**Town of Groveland**  
**Economic Development**  
**Planning & Conservation Department**  
**Planning Board**  
183 Main Street  
Groveland, MA 01834

**CONTINUED 181R SCHOOL STREET:**

APPLICATION FOR APPROVAL OF  
A DEFINITIVE PLAN

SUBDIVISION NAME 181R School Street PLAN# \_\_\_\_\_

REVISIONS			DRAWING NO.
NO.	DESCRIPTION	DATE	
			DRAINAGE DETAILS C-10

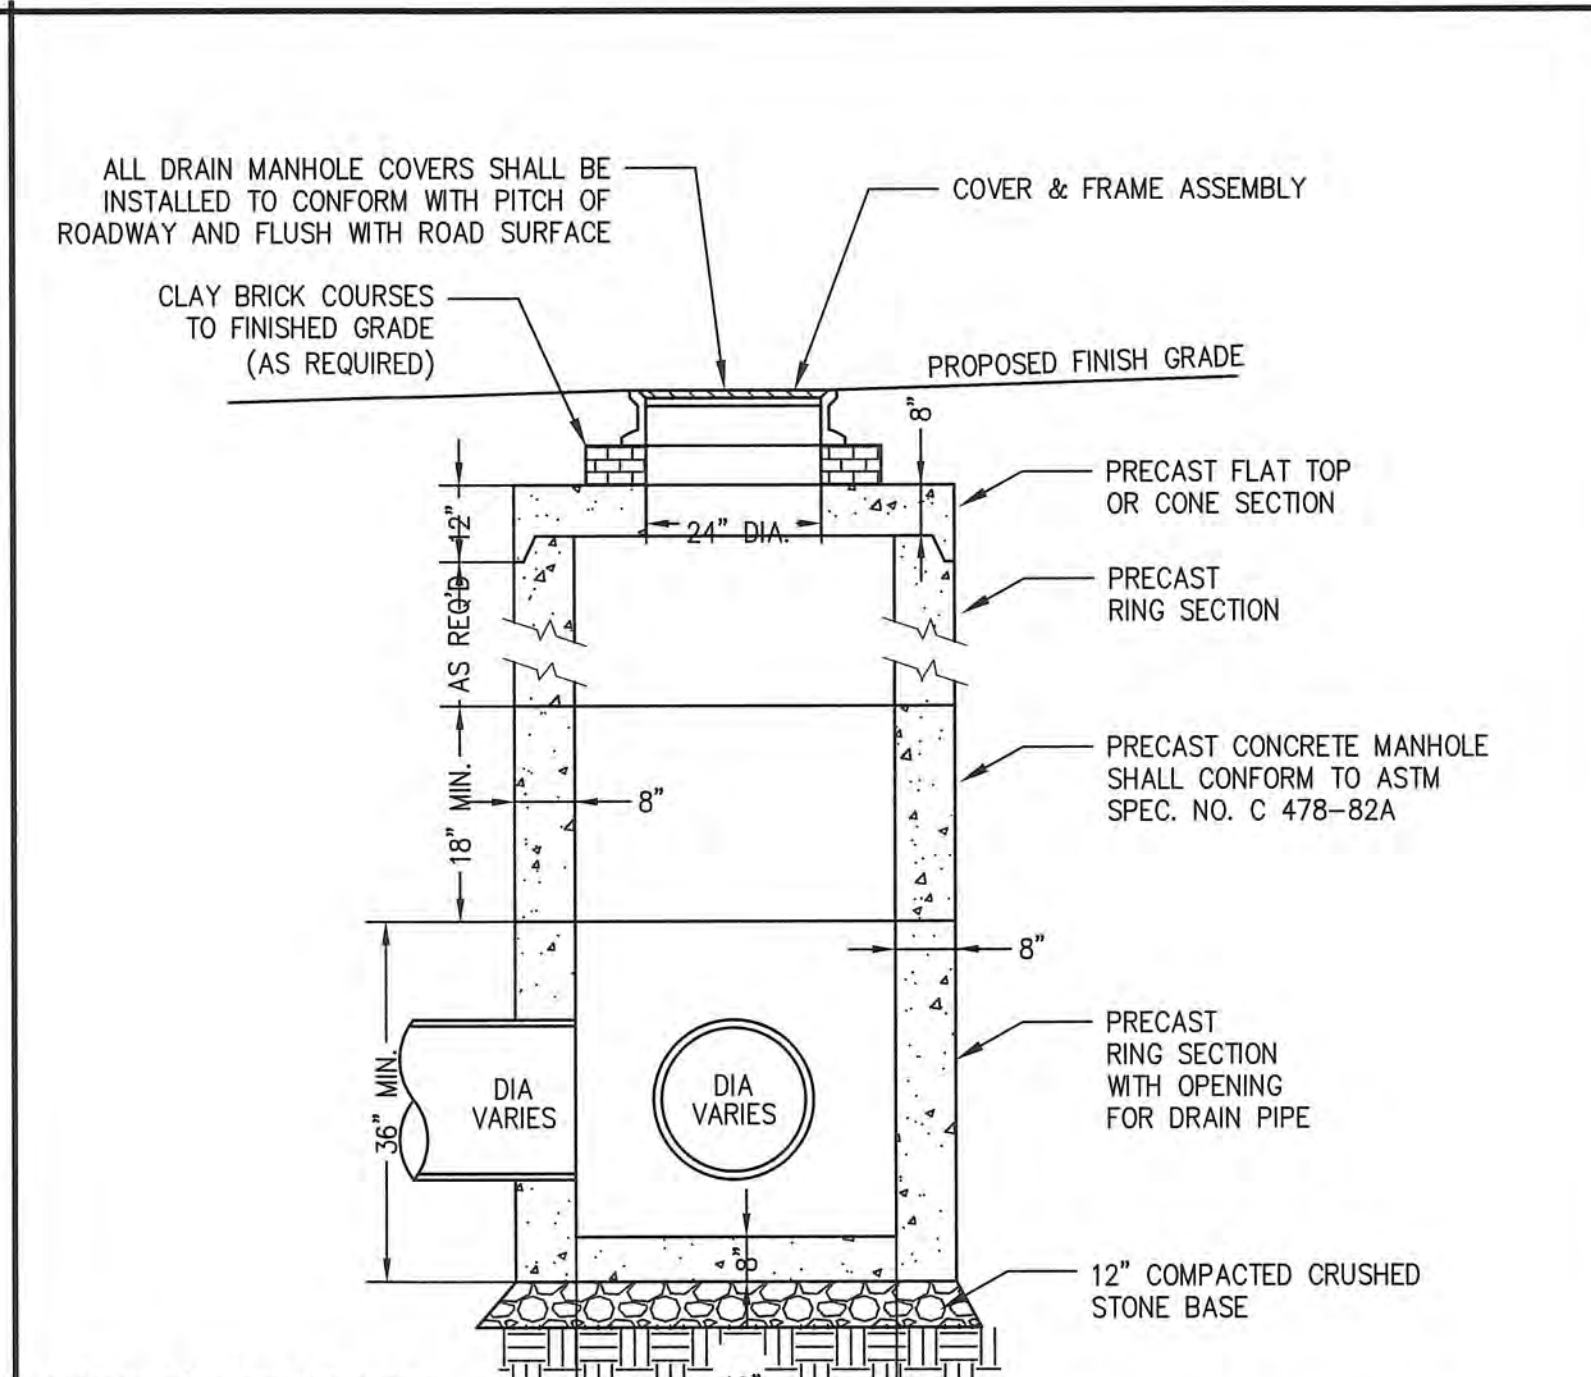
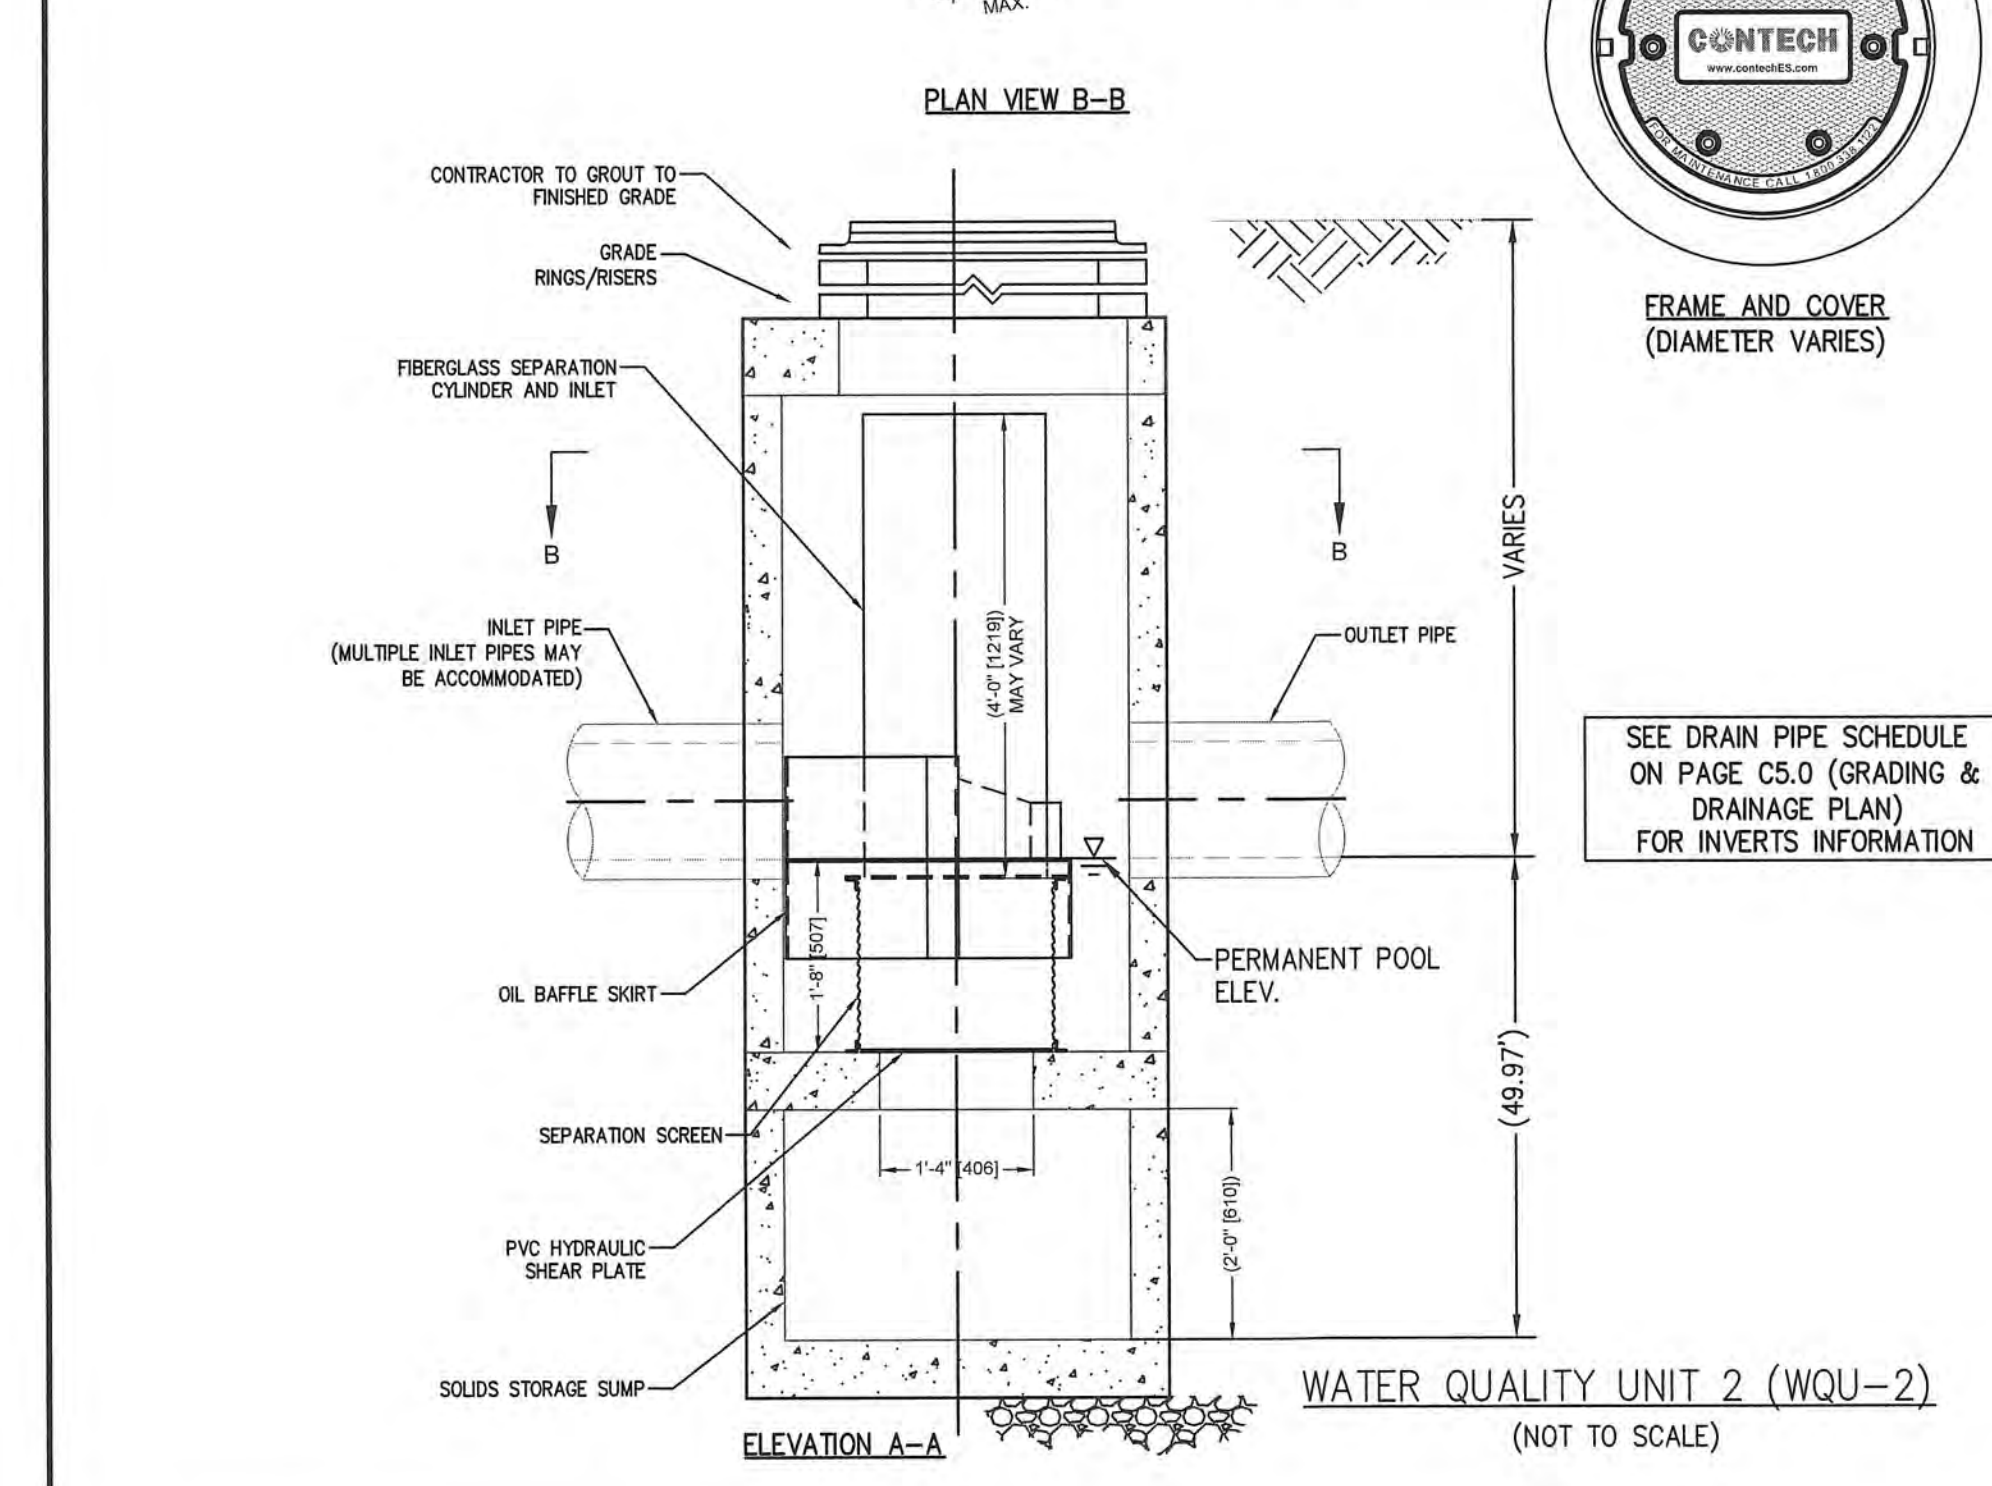
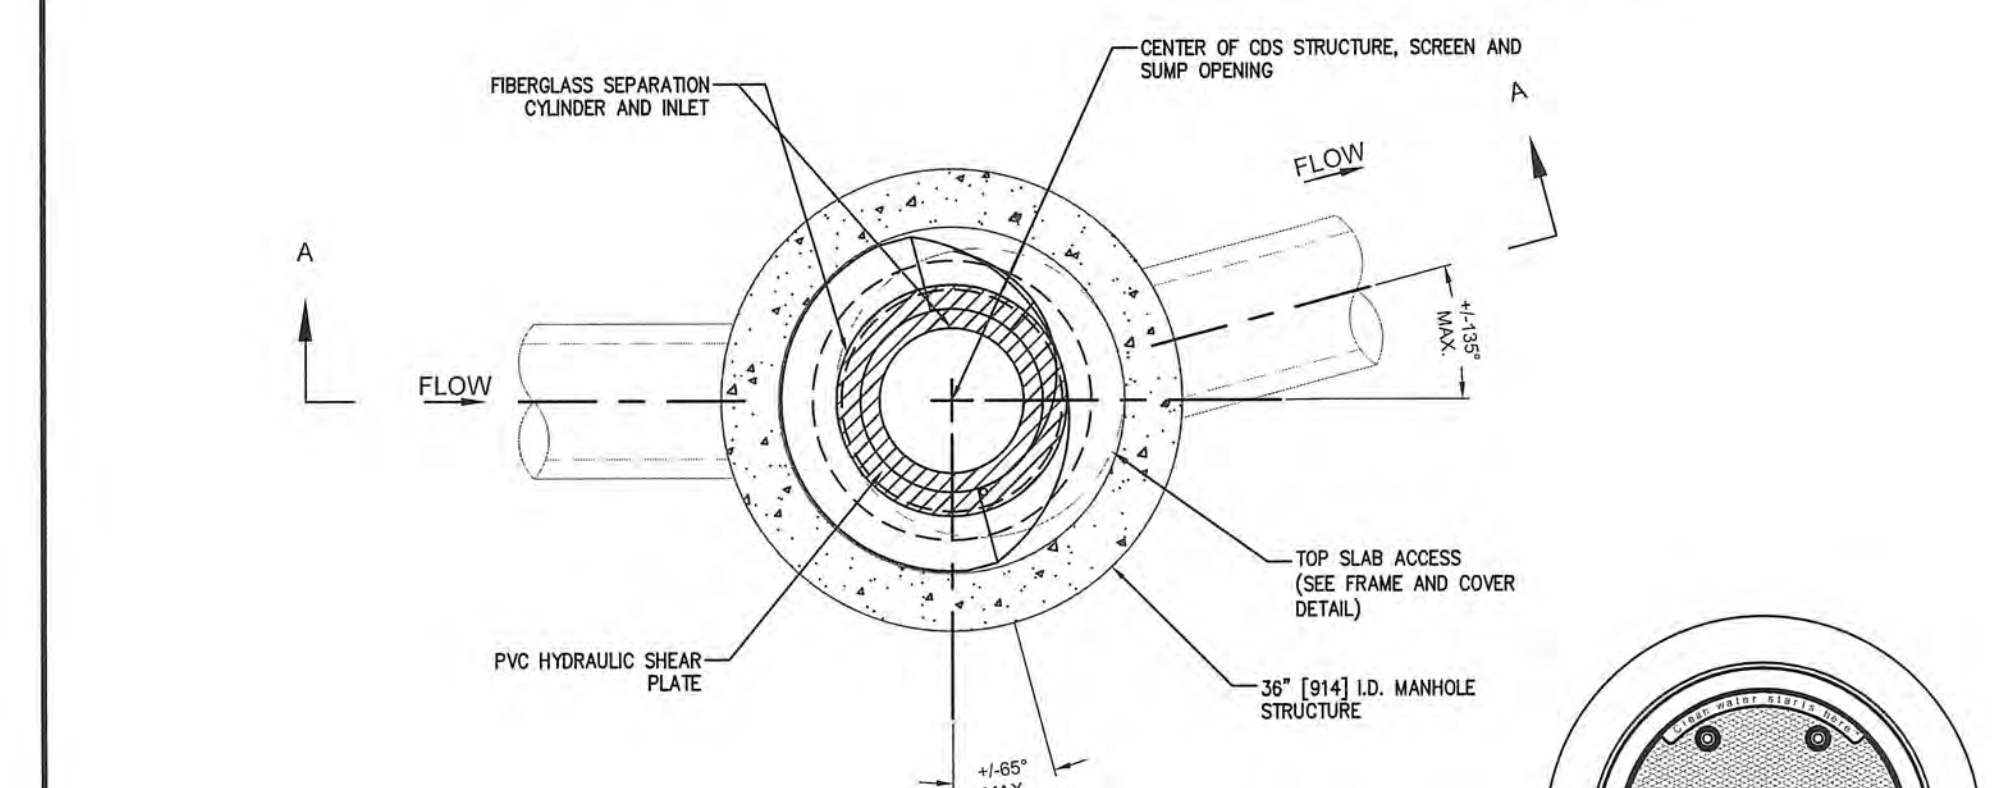
19. Infiltration basin P1 shows an ESHGWT (92.0') two feet above the proposed bottom of basin (90.0'). Chapter 2 Volume 2 of the Massachusetts Stormwater Handbook requires a minimum of two feet of separation between the bottom of a proposed infiltration basin and the ESHGWT.
20. TEC recommends mounding analysis to be completed for each proposed rain garden and infiltration basin.
21. For rain garden P6 shown on sheet C-6 of the site plans, the top of garden elevation is lower than the bottom of garden elevation. The applicant should revise this label accordingly.
22. On sheet C-10 of the site plans, the detail is labeled as OCS-2 instead of OCS-5.
